AHCERT-941506

**COMMENTS OF HONDA MOTOR CO., LTD.
REGARDING CARB MAIL-OUT #94-35
"UTILITY AND LAWN AND GARDEN EQUIPMENT ENGINES
PROPOSED AMENDMENTS"**

CALIFORNIA EXHAUST EMISSION STANDARDS AND TEST PROCEDURES

HONDA G100K1

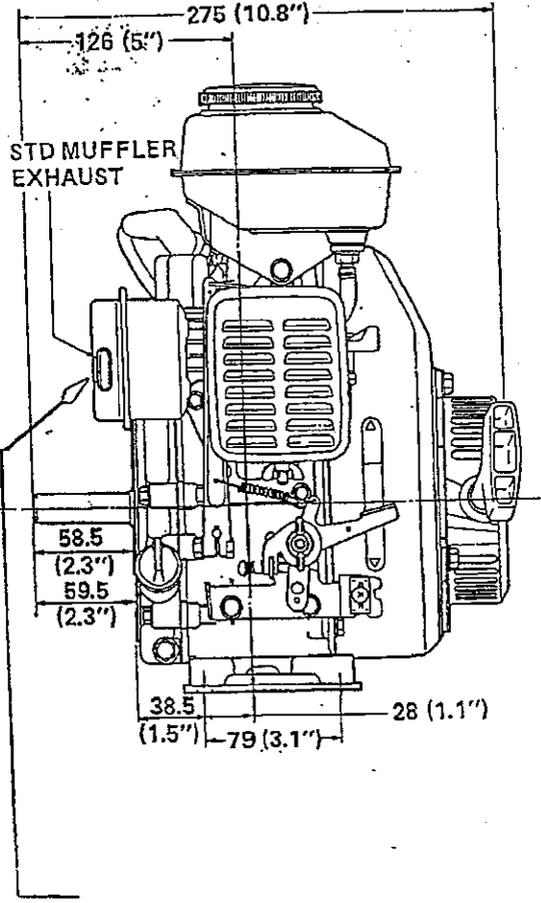
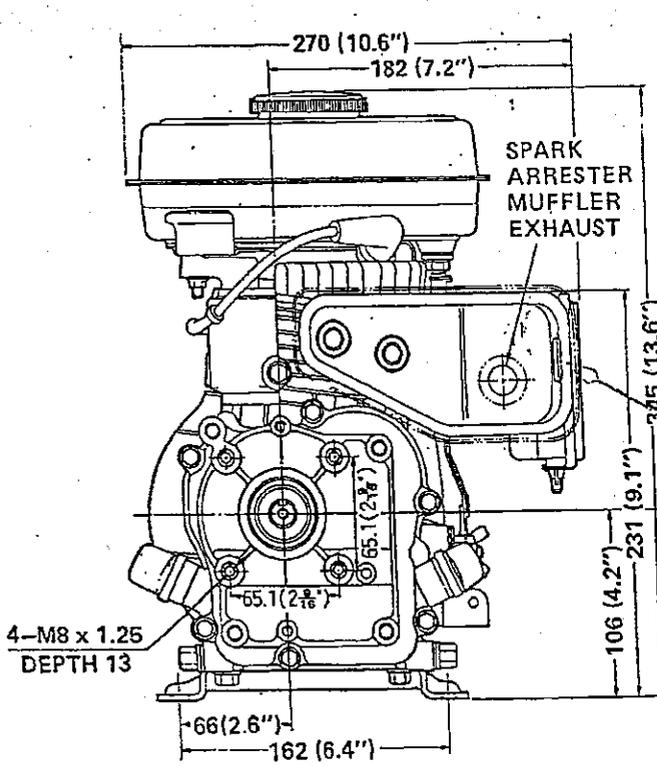
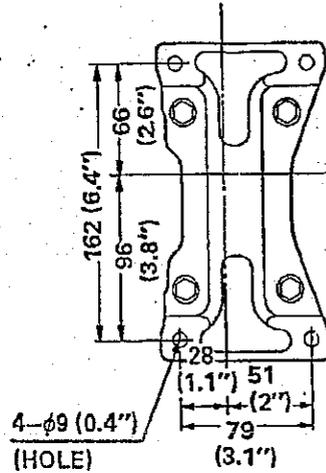
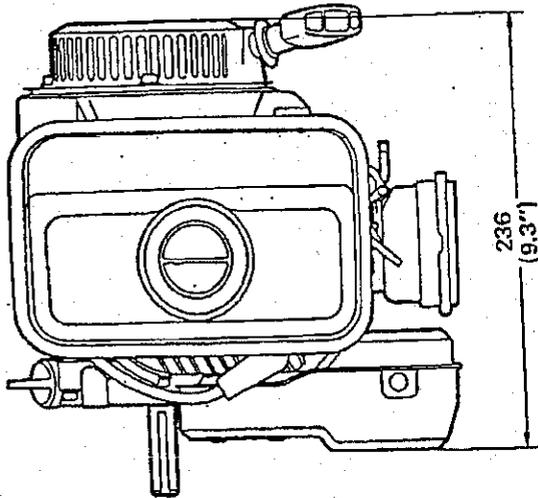
1. Basically, the exhaust gas regulations are intended to control the exhaust gas emitted from the engines, equipment or vehicles,
2. The exhaust gases in the muffler are not necessarily equivalent to the gases actually emitted from an engine's tail pipe,
3. We must avoid ingesting air from the atmosphere due to pressure pulsation in the exhaust,
4. Some small ULG engines, such as the Honda G100K1, have no exhaust conduit and no tailpipe (see attached drawing),

5. It is difficult to locate the sampling probe directly in the muffler of small ULG engines because it is too small,
6. If we locate a sampling probe in such a small muffler, the air from the atmosphere may be ingested into the sampling probe due to pressure pulsations in the exhaust and due to the small muffler size,
7. If we choose to use the mixing chamber, we will have to prepare mixing chambers of various sizes for our products depending upon engine displacement, and
8. Almost all 2 stroke engines for string trimmers would have the same problems mentioned above as G100K1.

From the reasons described above, Honda considers that the use of an additional tail pipe is reasonable and that ARB should renumber 2.(d)(2)(ix) of "Part II. Raw Gas Method Test Procedures" in attachment B of ARB Mail-out #94-24 to 2.(d)(2)(x) and add the following sentences as 2.(d)(2)(ix).

(ix) The exhaust sampling probe shall be located at the optional additional tail pipe when an additional tail pipe is used in the test set up. The exhaust sample probe shall not be so close to the exhaust outlet as to ingest air from the atmosphere due to pressure pulsations in the exhaust.

In addition to that, the long tail pipe in Figure 2-1 should be drawn by dotted line and should be identified as "(optional)".
